Access Compliance Report

Public Rights-of-Way

(Curb Ramps)

Intersection ID: 49274	Main Street: ROTHE_HOUSE_RD	Cross Street: REMINISCE_LN	Location: S
ADA ID: 93F1ACE49624	Ramp Type: PerpDiag	Initial Pass/Fail: Fail	Overall Compliance: No
		Severity Score: 35

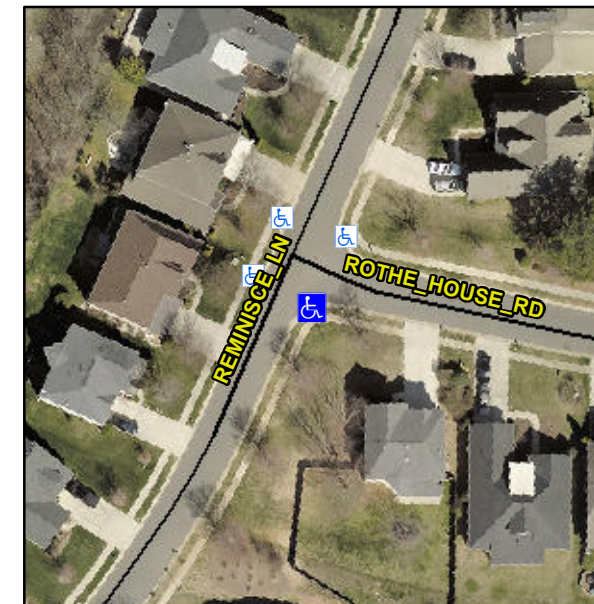
Not Found, R304.5.1, R304.2.2, R304.5.3

Compliance	Description	Data	Compliance	Description	Data
N/A	Ramp Length (in)	46.5	No	Ramp Slope (%)	13.2
No	Ramp Width (in)	47.3	No	Ramp XSlope (%)	2.9
N/A	Flare Type LT	N/A	N/A	Flare Type RT	N/A
N/A	Flare Slope LT (%)	N/A	N/A	Flare Slope RT (%)	N/A
N/A	Flare Traversable LT?	N/A	N/A	Flare Traversable RT?	N/A
N/A	Landing Length (in)	N/A	N/A	DWS Provided?	N/A
N/A	Landing Width (in)	N/A	N/A	DWS Contrast?	N/A
N/A	Landing Slope (%)	N/A	N/A	DWS Length (in)	N/A
N/A	Landing X Slope (%)	N/A	N/A	DWS Full Width?	N/A
N/A	Landing Curb? (Y/N)	N/A	N/A	DWS Offset (in)	N/A
N/A	Shared Landing?	N/A			
N/A	Gutter Ponding?	N/A	N/A	Gutter Slope (%)	N/A
N/A	Gutter Lip Ht (in)	N/A	N/A	Gutter X Slope (%)	N/A
N/A	Painted X Walk1?	No	N/A	Painted X Walk2?	No
	X Walk 1 Direction	To NE		X Walk 2 Direction	To NW
N/A	X Walk 1 Width (in)	N/A	N/A	X Walk 2 Width (in)	N/A
	X Walk 1 Slope (%)	5.8		X Walk 2 Slope (%)	5.9
	X Walk 1 X Slope (%)	3.1		X Walk 2 X Slope (%)	1.2

Remove & Replace Curb Ramp With Two New Directional Ramps or Equivalent.
